Emplacement Inspection Report

EPA INSPECTION No. EPA-WIPP-6.06-20c
OF THE
WASTE ISOLATION PILOT PLANT
June 20-22, 2006

U. S. ENVIRONMENTAL PROTECTION AGENCY
Office of Radiation and Indoor Air
Center for the Waste Isolation Pilot Plant
401 M. Street, S. W.
Washington, DC 20460

September 2006

Figure 2. Additional MgO is placed in stacks five supersacks high in BRTs in order to assure an MgO safety factor above 1.67 before room closure. (Figure is from the 2005 inspection).

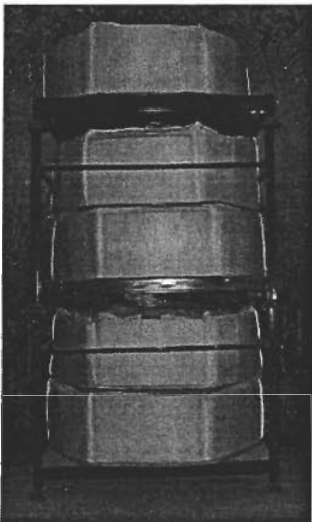
Some (1-2 feet) space between the repository wall and the waste column may be left open, however, waste packages may be placed touching or nearly touching the repository wall. A second row of three columns is emplaced parallel to the first, with each column placed between two columns from the previous row to minimize unusable space. MgO is placed on top of each column in 4,200 pound super sacks. When additional MgO is needed before room closure, DOE will place stacks of five MgO supersacks in a column on BRTs (big red things). See Figure 2.

WH.01 Revision 0). The EPA inspectors observed that MgO had been placed properly in each row that was visible. The MgO is placed on top of each waste column in supersacks [Figure 3] or on the BRTs [Figure 2] when additional MgO is needed.

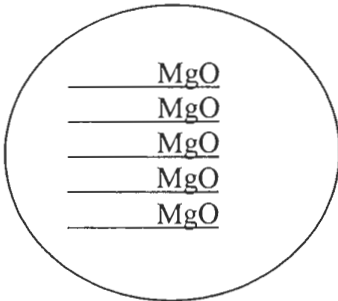
| # | <u>Question: Waste Emplacement</u> | Comments and Objective Evidence | Results |
|----|--|--|--------------|
| 7 | Are Super Sacks placed on top of waste stacks as described in Volume 1, Section 3.3.3 of the CCA; approximately 4,000 lbs, multi-wall construction with a vapor and moisture barrier? | Yes. Visual observation (See pictures below). | Satisfactory |

Attachment D Draft Procedure Flowchart for Adding MgO

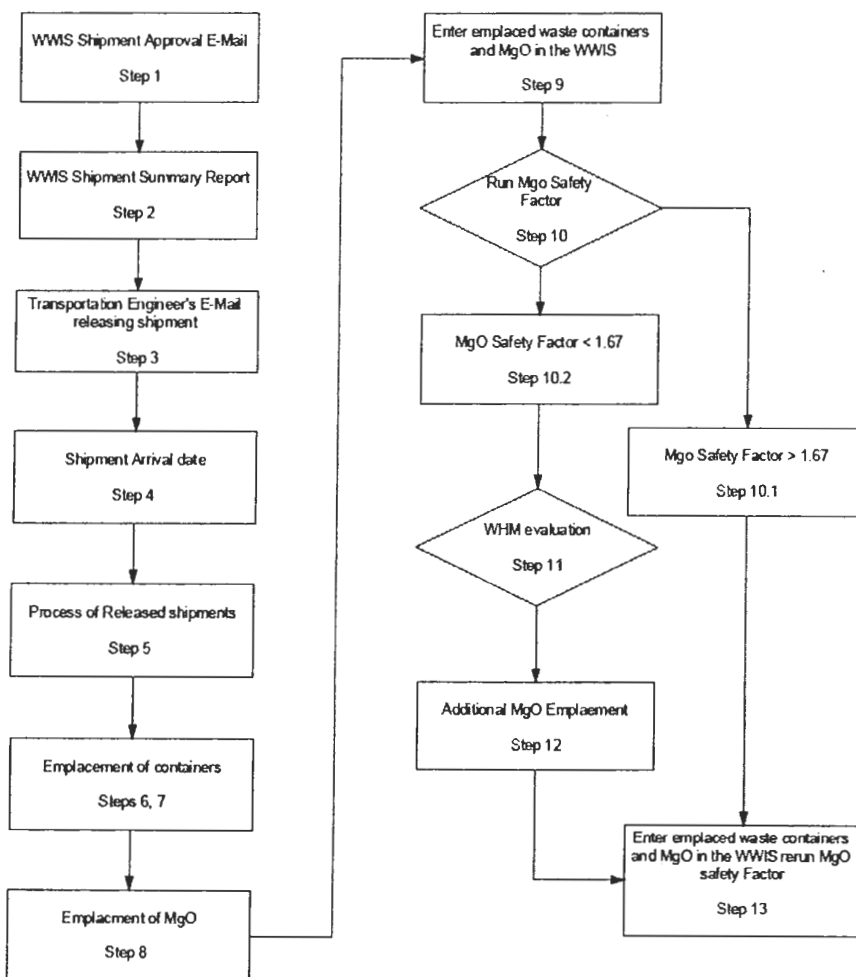
| # | Question: <u>Waste Emplacement</u> | Comments and Objective Evidence | Results |
|----|---|---|--------------|
| 9 | Is there documentation that identifies, for the WHE or WHM (or other appropriate personnel), where the additional MgO should be placed? | <p>DOE uses Big Red Things (BRTs) to hold columns of MgO when extra is needed. BRTs are noted in the underground map as a stack of 5 MgO layers as diagrammed below.</p>  <p>2005 Training notes address this. See Attachment C. The training notes will be superseded by the update WIPP Waste Handling Operations WWIS User's Manual (Attachment D).</p> | Satisfactory |
| 10 | Is there documentation that identifies how the MgO should be placed with high CPR waste? | 2005 Training notes address this. See Attachment C. The training notes will be superseded by the update WIPP Waste Handling Operations WWIS User's Manual (Attachment D). | Satisfactory |
